# Structure Description and Construction Plan

## Waste Rock, Ore Storage and Trails

For MV2020L2-0002

March, 2022

Figure 1. Schematic drawing for Waste Storage

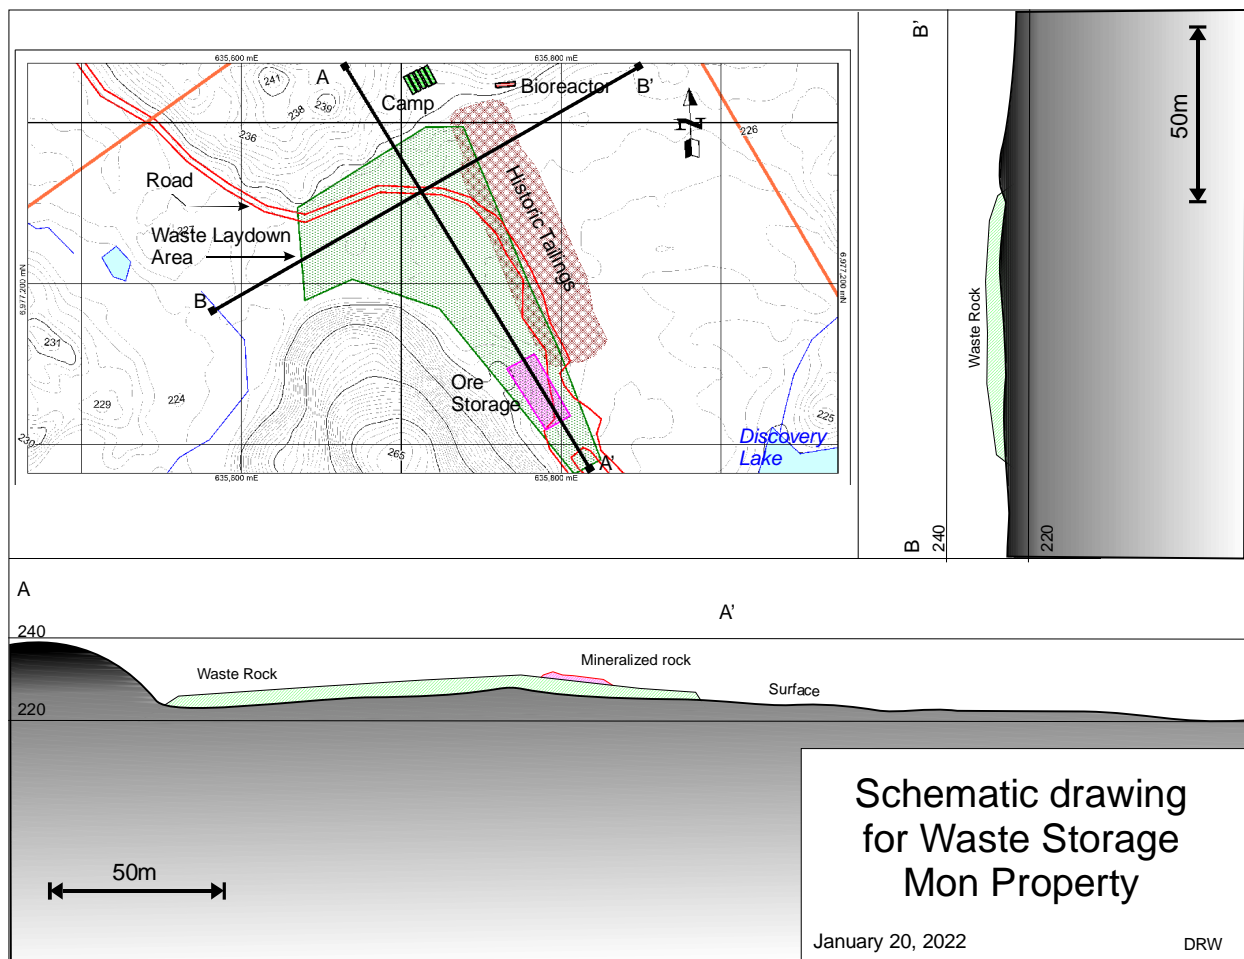
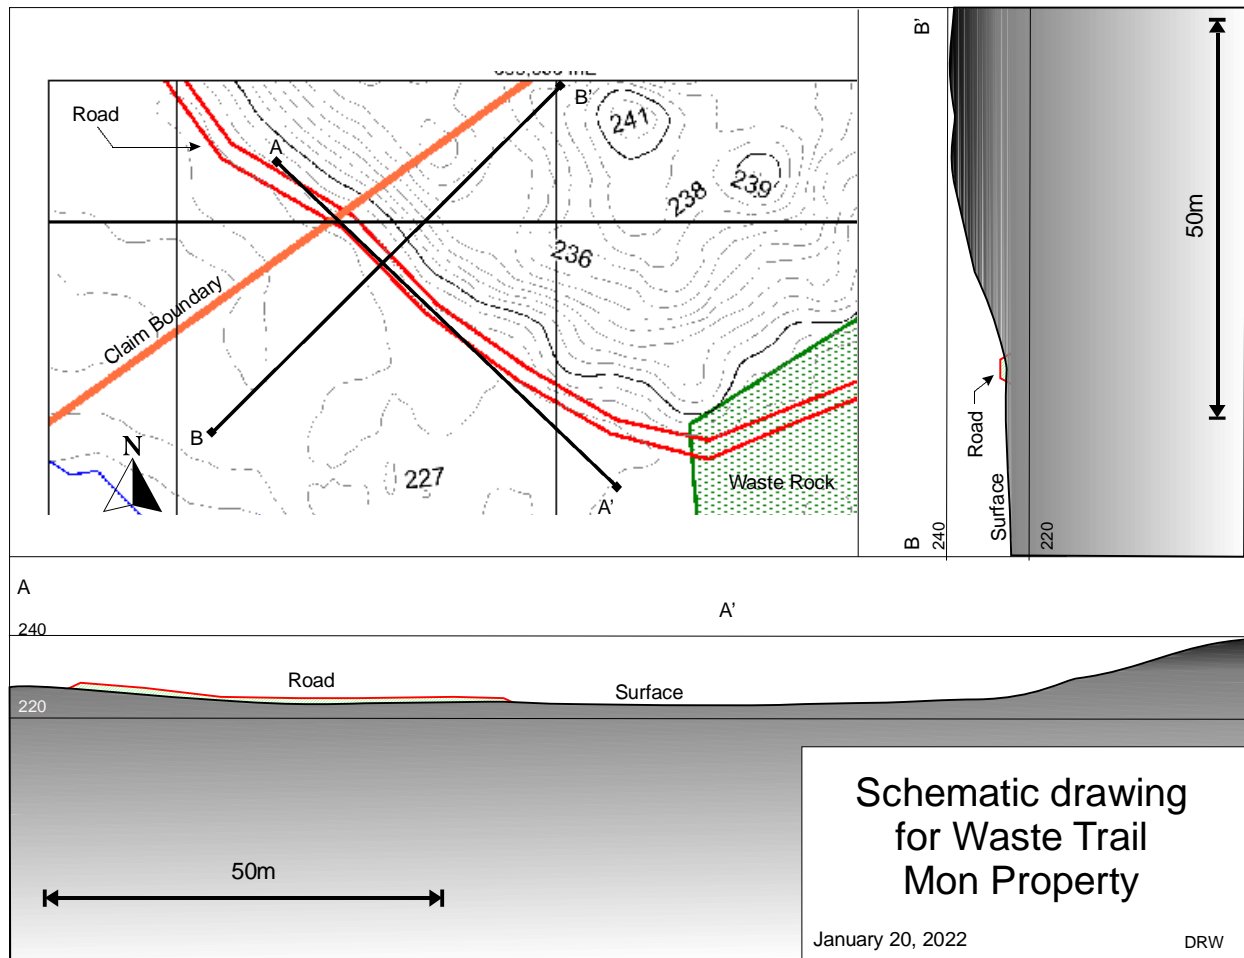
4	Legend – Figures 1 and 2	ENR notes that neither Figure 1 nor Figure 2 of the Plan includes a legend.	ENR recommends that NDM include a legend for both Figures 1 and 2.	Labels added. Figure 1, page 8, Figure 2, page 9
